TECHNICAL STAFF REPORT Lawyers Hill Overlook

Planning Board Quasi-Judicial Public Hearing of June 6, 2019

PB Case No. 445 Lawyers Hill Overlook / Land Design and Development,

SP-19-002 Lawyers Hill Overlook, Lots 1-17 & Open Space Lot 18

5P-19-002

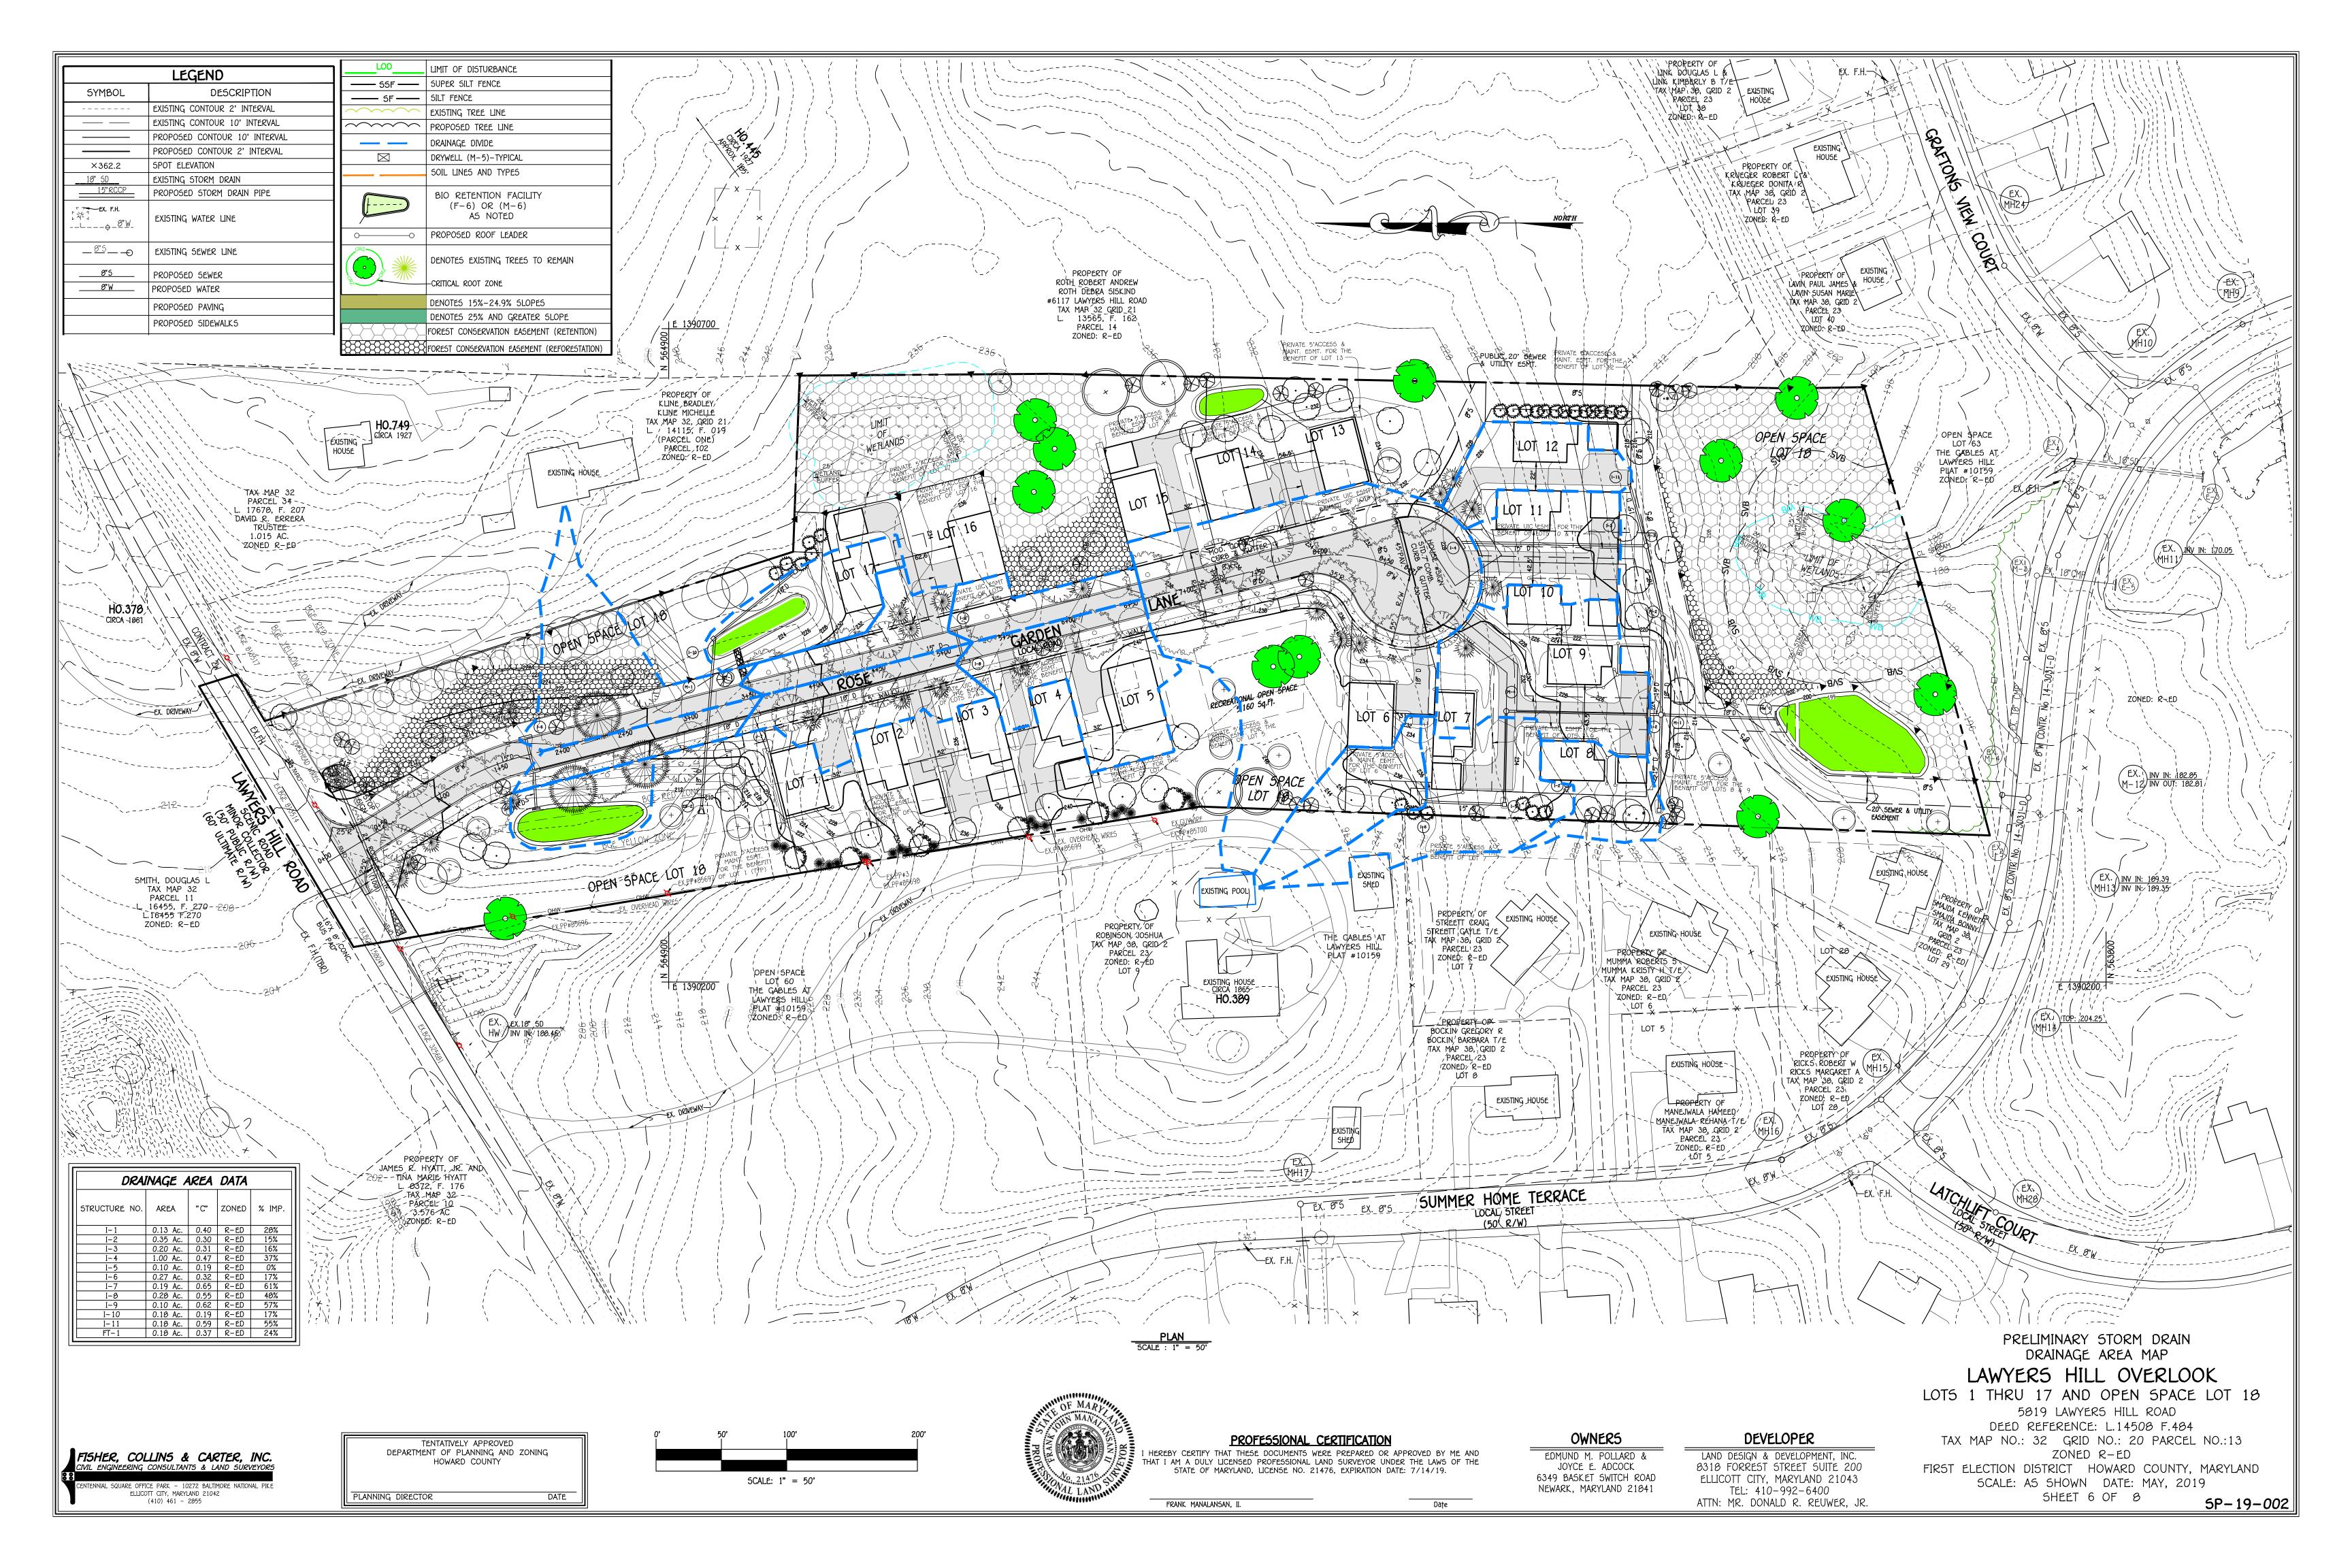
Mr. Reich stated that the plans showed a row of trees along the entry road and scattered deciduous trees around the perimeter of the houses. Mr. Reich asked which specimen trees were getting saved. Mr. Reich pointed to parts of the plan for Mr. Reuwer to confirm trees that were being saved. Mr. Reich asked about the evergreen trees on the plan. Mr. Reuwer stated those trees were being added and stated they were proposing to have trees to keep anyone who did not want to see the subdivision from seeing it. Mr. Reuwer said the stormwater management plan was tweaked so the evergreen trees by Ms. Kline's property would remain and not be removed. Mr. Reich stated it seemed on the south side by the Robinson house, the buffer was sparse. Mr. Reuwer said he was putting a thick buffer around the subdivision and was happy to have a thicker buffer in that open space. Mr. Reuwer stated he had a 30-foot setback that allowed for that.

Mr. Taylor asked if the specimen tree plan showed all of the trees. Mr. Reuwer said it did. Ms. Burgess clarified it showed all trees 30 inches in diameter or greater. Mr. Reuwer stated that was the definition of a specimen tree. Mr. Reich confirmed that there were 23 specimen trees on the specimen tree list and they matched the specimen trees shown on the plan. Mr. Shad confirmed that the plan and tree list matched.

Mr. Roth stated the preliminary sketch plan provided by the Applicant does not show either of the historic resources identified by the Commission in the advisory comments from April 2018. Mr. Roth advised that it should be revised before the Department of Planning and Zoning undertakes any further consideration of the proposal.

Mr. Roth stated the preliminary sketch plan provided by the Applicant does not show either of the historic resources identified by the Commission in the advisory comments from April 2018. Mr. Roth advised that it should be revised before the Department of Planning and Zoning undertakes any further consideration of the proposal.

- Relocated Open Space Lots to provide enhanced screening of the neighboring historic home known as The Gables (HO 389).
- Relocated several buildable lots to save more specimen trees.
- Modified the garage location to be either side loaded or detached and located behind the homes.
- Selected street tree species, location, and sizes to replicate the patterns found in the Lawyers Hill Historic District.
- Located the existing historic well house on a proposed Open Space Lot to help protect and buffer it.
